# CITY OF PLANO COUNCIL AGENDA ITEM

**Subject:** Appeal of the Heritage Commission's denial of a Certificate of Appropriateness to construct a 63,292 square foot, five-story structure at 1400 J Avenue.

**Certificate of Appropriateness CA2016-004:** 1400 J Avenue

**A5.11 EXTERIOR ELEVATION**

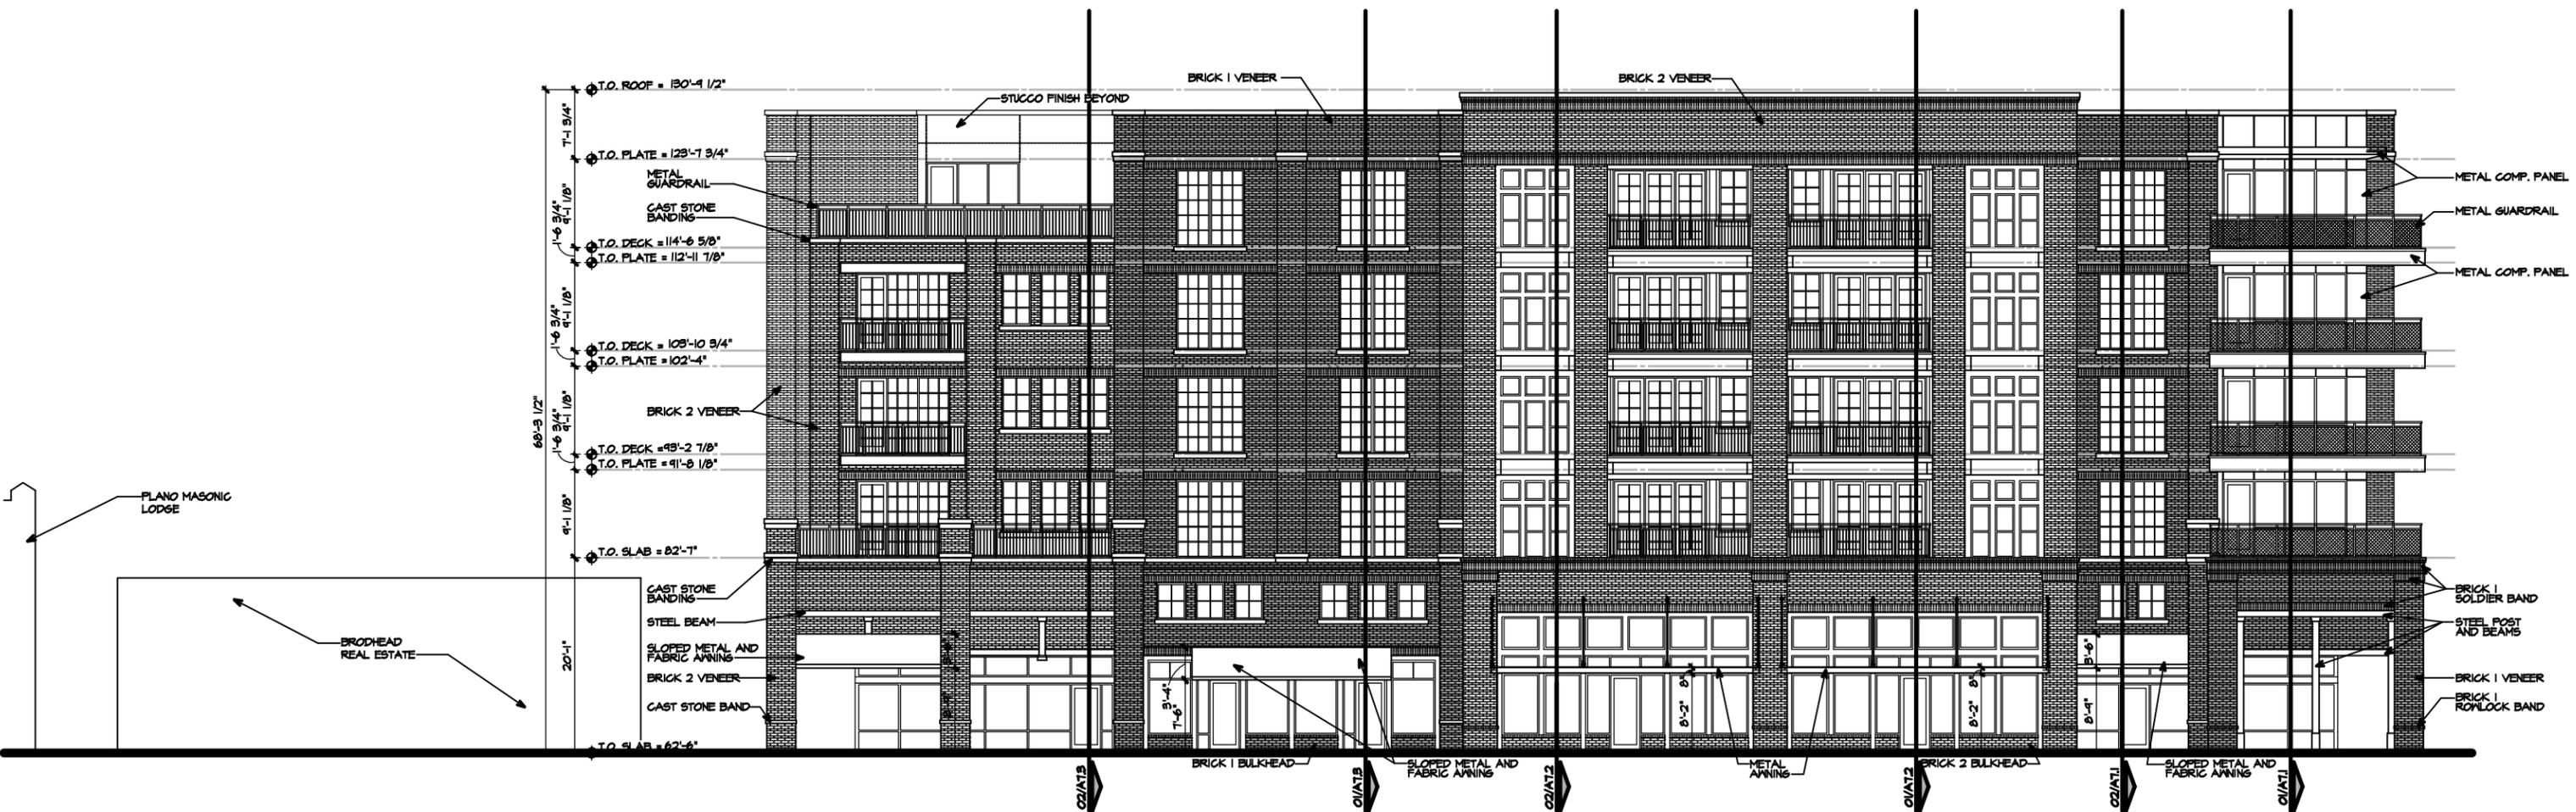
Commissioners who voted in favor of denying the requested CA noted that the structure's proposed height of 68 feet is more than twice the 32-foot maximum permitted under Section 10.4 of the Downtown Heritage District Design Guidelines, which state that "the height of a new building should not exceed the height of the tallest building on the block." Since the tallest existing building on the relevant block of J Avenue is only 32 feet tall, the requested height of 68 feet is more than twice the maximum permitted under the Downtown Heritage District Design Guidelines. Commissioners who voted in favor of denial also felt that the massing and scale of the proposed structure violated Section 10.1 of the Downtown Heritage District Design Guidelines. In addition, Commissioners who voted in favor of denial emphasized that, whether or not the Downtown Heritage District Design Guidelines mandated denial of the CA, they felt denial of the CA was warranted because the construction of such a tall structure within the Downtown Heritage District was incompatible with the scale of the Downtown Heritage District and would impact sightlines in the Downtown Heritage District, alter the look and feel of the Downtown Heritage District, and potentially hamper efforts to get the Downtown Heritage District accepted for inclusion in the National Register of Historic Places. Finally, these Commissioners also expressed concerns that allowing a five-story structure in this location would set a precedent that could lead to the construction of other overly tall structures in the Downtown Heritage District.

Section 10.4 of the DHDD Guidelines state: “the height of a new building should not exceed the height of the tallest building on the block.” Therefore, the request for a 68-foot high structure maintains the height of the buildings along 14th Street, based on the applicant’s proposed building on Lot 1 which is 70 feet in height, but does not maintain the height of the buildings located along J Avenue within the Heritage District, as the highest building is 32 feet high. However, the buildings immediately across the street to the south and west, while outside the district, are of similar height to the request (see Attachment 3 - Massing Model Images). The following is a table listing staff suggestions related to section 10.4 and the applicant’s comments:

Staff Suggestions	Applicant Comments
<p>Consider reducing the impact of proposed height by:</p> <ul style="list-style-type: none"> <li>• Additional incremental transition of the building height starting from the facade at the northwest corner up to a five story facade moving south. This would likely result in a loss of units or smaller units in those locations.</li> <li>• Stepping back the upper stories from the street facing wall planes (primary plane) to ensure the historic building proportions and profile are not radically changed. The primary plane of the west facade must not appear taller than the existing tallest building in the block. The back side (secondary plane) of the west façade may be taller incrementally, as shown on the northwest corner.</li> </ul>	<ul style="list-style-type: none"> <li>• The upper three floors at the northwest corner of the building are setback approximately 9'-0" from the building line at the front (west) and the north facades. The design is intended to closely align the first floor height of the proposed building with the existing one-story structure located to the north at 1412 J Avenue;</li> <li>• The proposed building height meets the Development Regulations for the Downtown Business/ Government (BG) Zoning;</li> <li>• The additional building height is required to allow the project to meet the density requirements per business agreement with the City of Plano; and</li> <li>• The building height is required to make the overall project financially feasible.</li> </ul>
